From: Jurek, Anne, Env. Health
Sent: Friday, June 24, 2016 11:57 AM
To: 'Michael Boettger'; Mark Drollinger
Cc: Roe, Dilan, Env. Health; Jurek, Anne, Env. Health
Subject: Response to Work Plan for SLIC Case RO0002896 and GeoTracker Global ID T06019794669, Red Star Yeast/1396 Fifth Street LLC, 1396 5th Street, Oakland, CA 94607

**Phase II Subsurface Investigation Work Plan
- Draft**

Former Red Star Senior Living Apartments Development
1396 Fifth Street
Oakland, California 94607

Figure 5

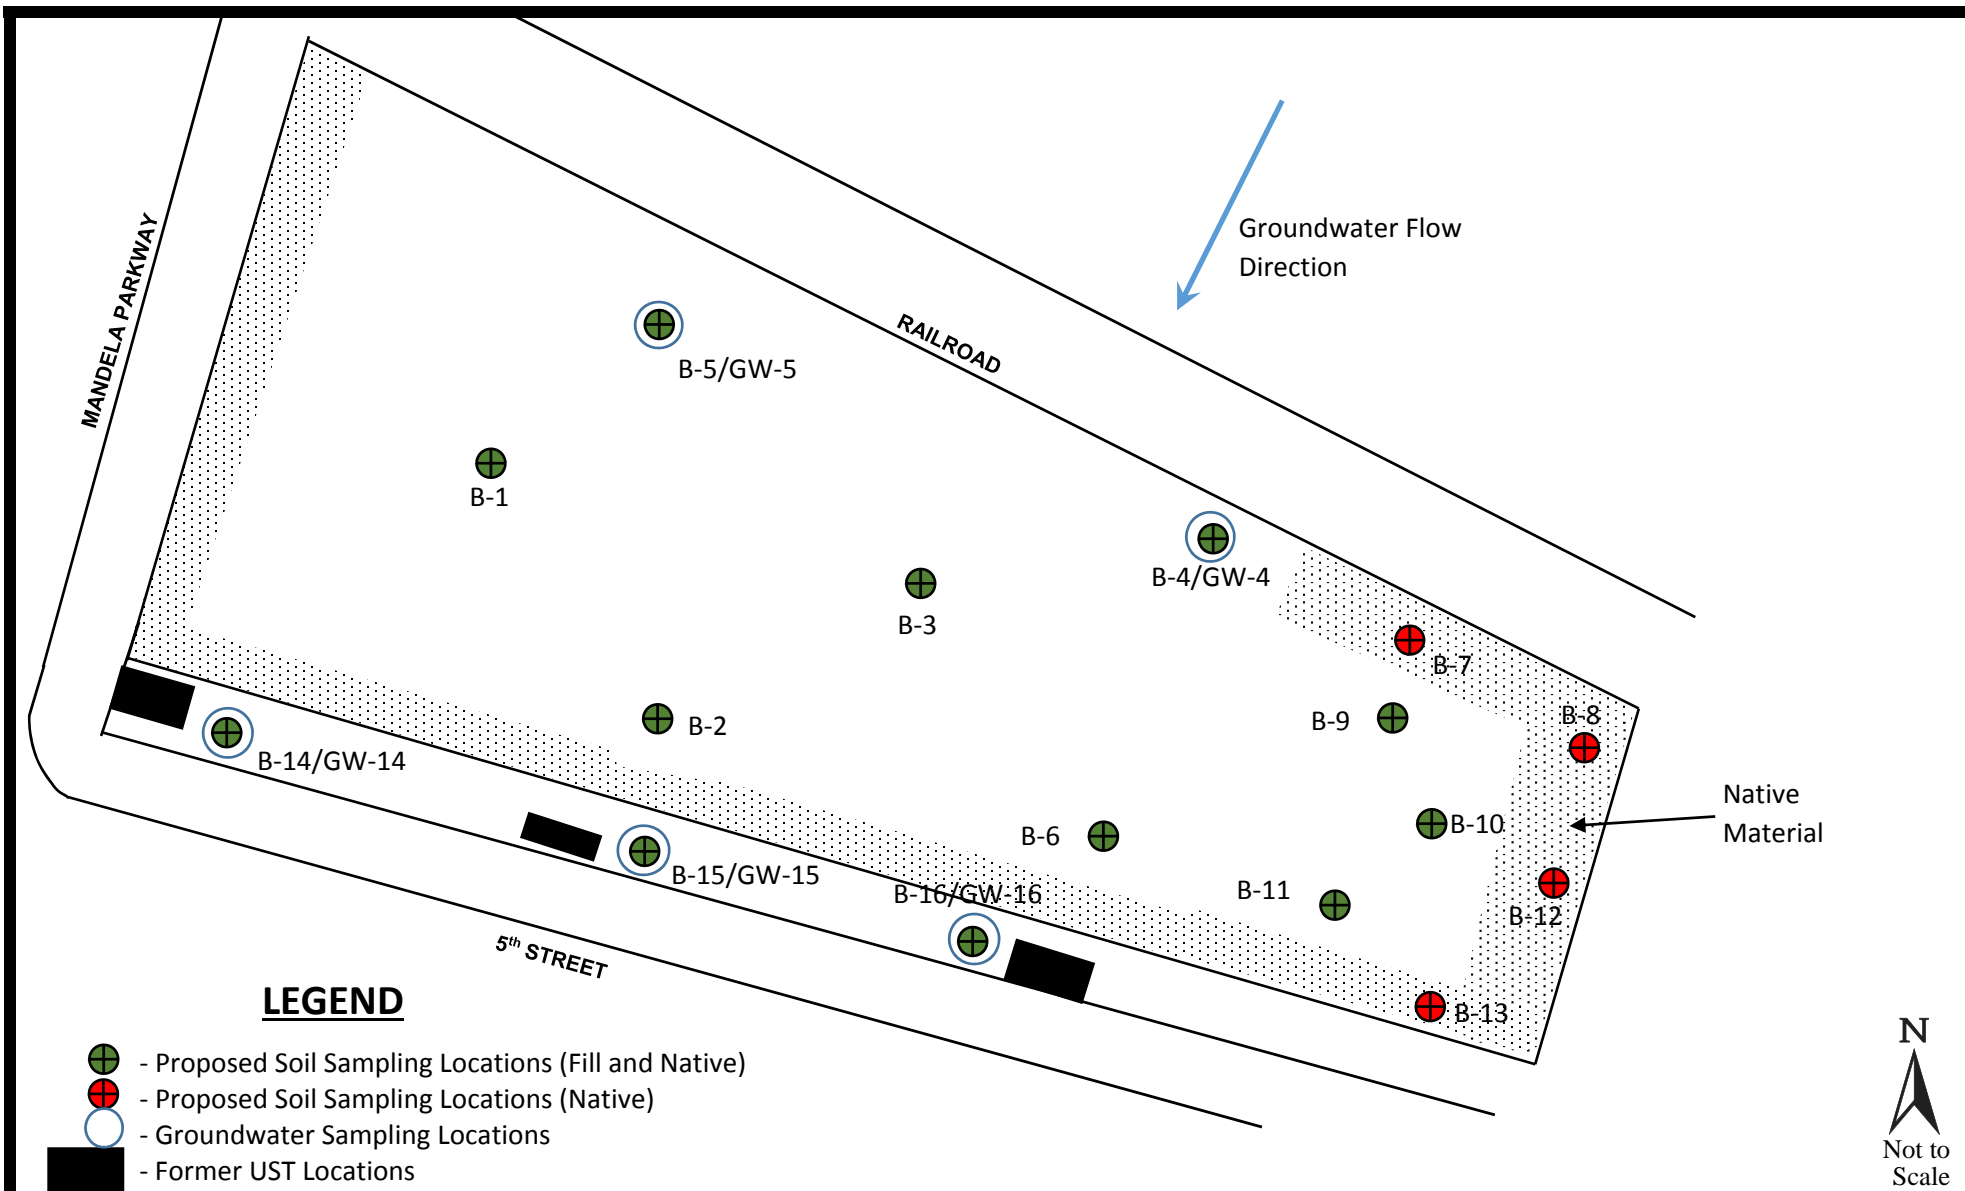
Fill and Native Soil Sampling: The work plan proposes that continuous cores be collected at only two fill locations. As per our previous discussions, continuous coring is necessary at all fill sampling locations in order to determine if there is more than one fill source. The presence of more than one fill source is one of the triggers of the contingency sampling. ACDEH requests that continuous cores be collected at all fill sampling locations and also at the native soil sampling locations at the easternmost boundary of the site. Complete boring logs with the PID readings should be included in the report.

Fill Sampling Locations: Boring B-10 in the proposed plan can be eliminated during the investigation.

Figure 6

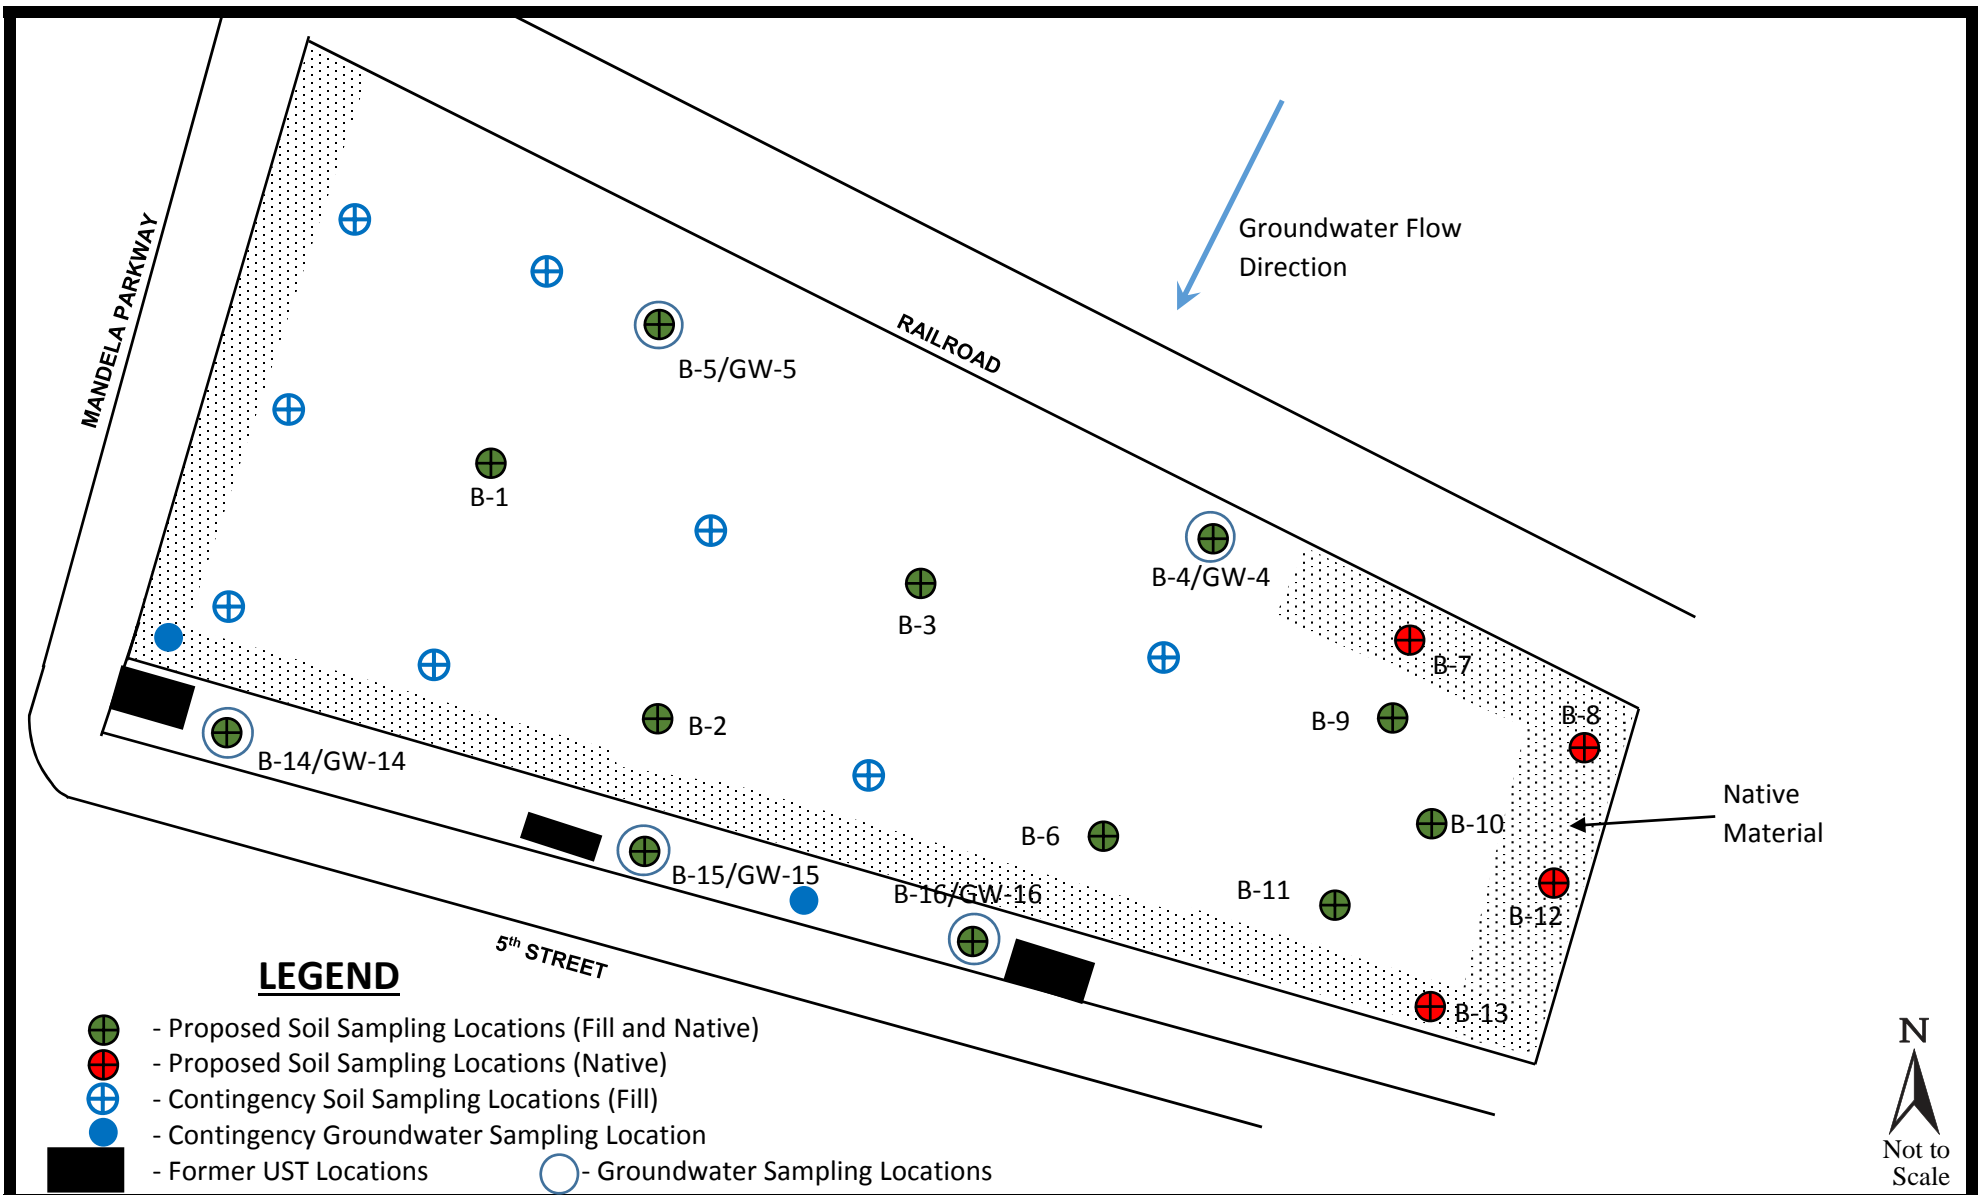
Sampling Location Figure: In the final revised work plan, please include only one figure that has the proposed and the contingency sampling locations.
